SITE INSTRUCTION

SI A10

PROJECT : Forestside
PROJECT # : 1331.15
DATE : Oct. 8, 2021

Title: Revisions to plans as itemized.

1:50 A-301a1

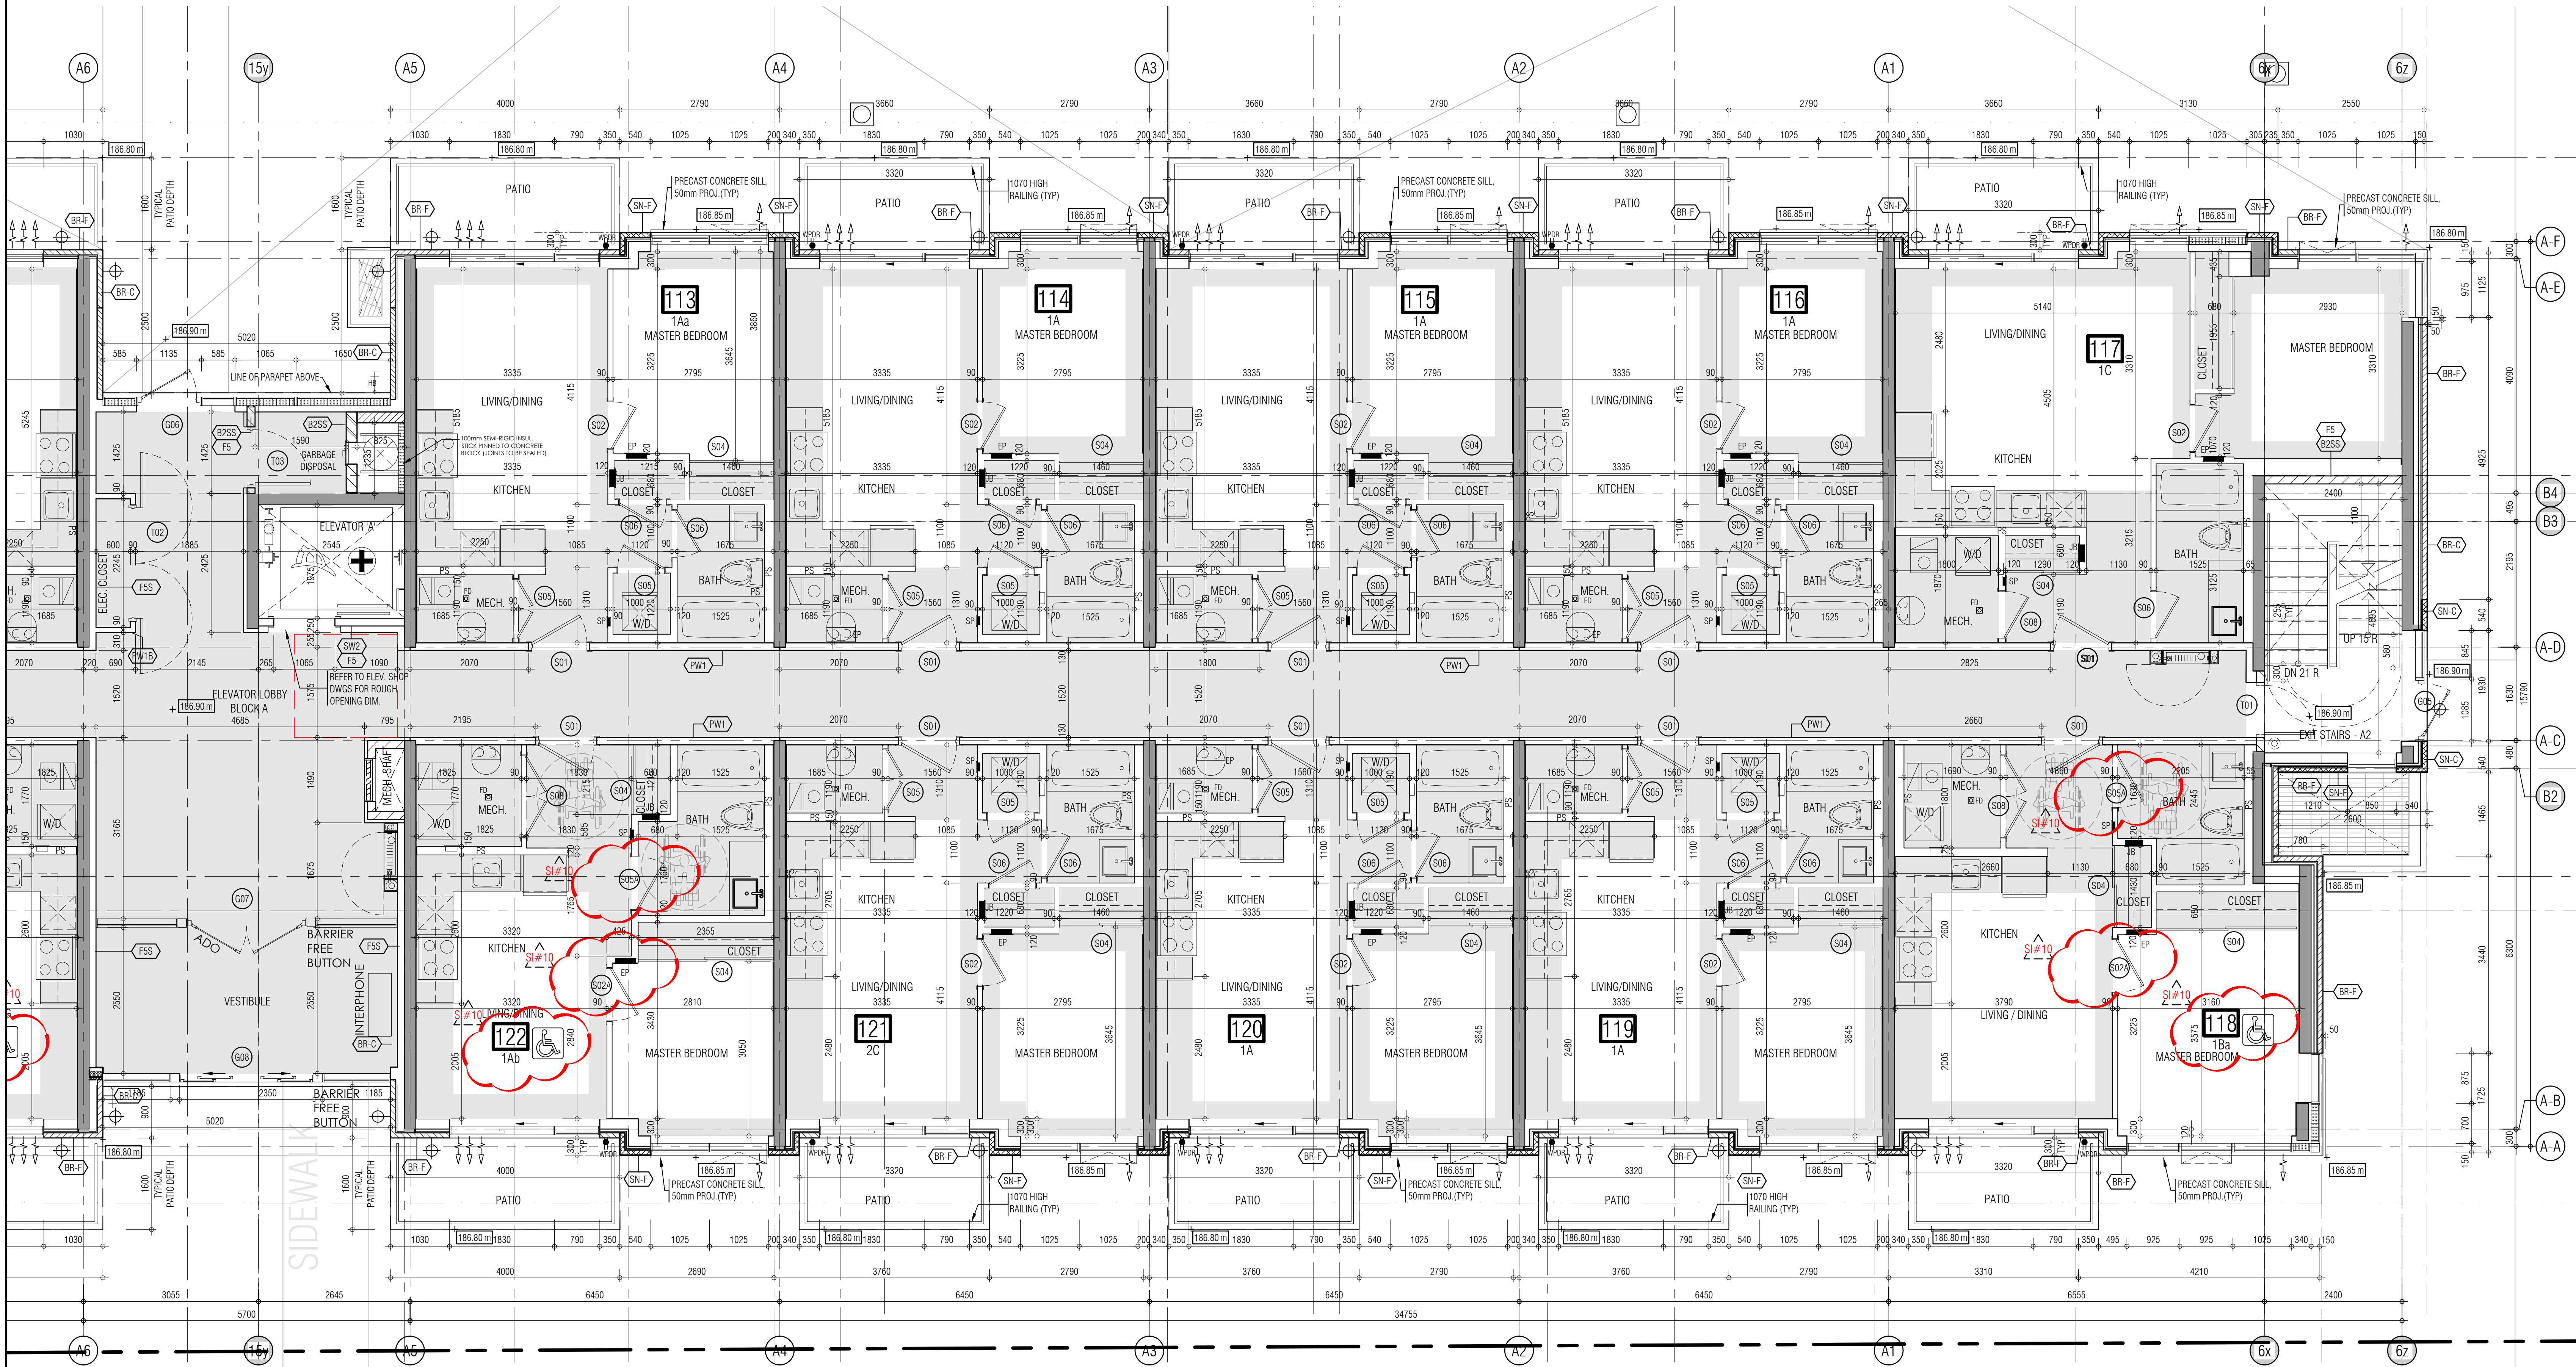
Reference:		Changes:
A103	Door Schedule	Updated doors for accessible suites.
A301, A302	1 st and 2 nd Floor Plans Bldg. A B C & D	- Added accessible suites to 2 bedroom and 3 bedroom units on the ground floor of buildings C and D. - Revised accessible suites dimensioning and labelling on the ground and second floor plans.
A305's	Roof Plans Buildings A B C and D	- Relocated scupper locations on roof plans closer to lower roof area to avoid draining onto lower roof. - Added additional scupper drain to lower roof.
A800	Typical Details	Added Universal Washroom to Typical Details Page 813.
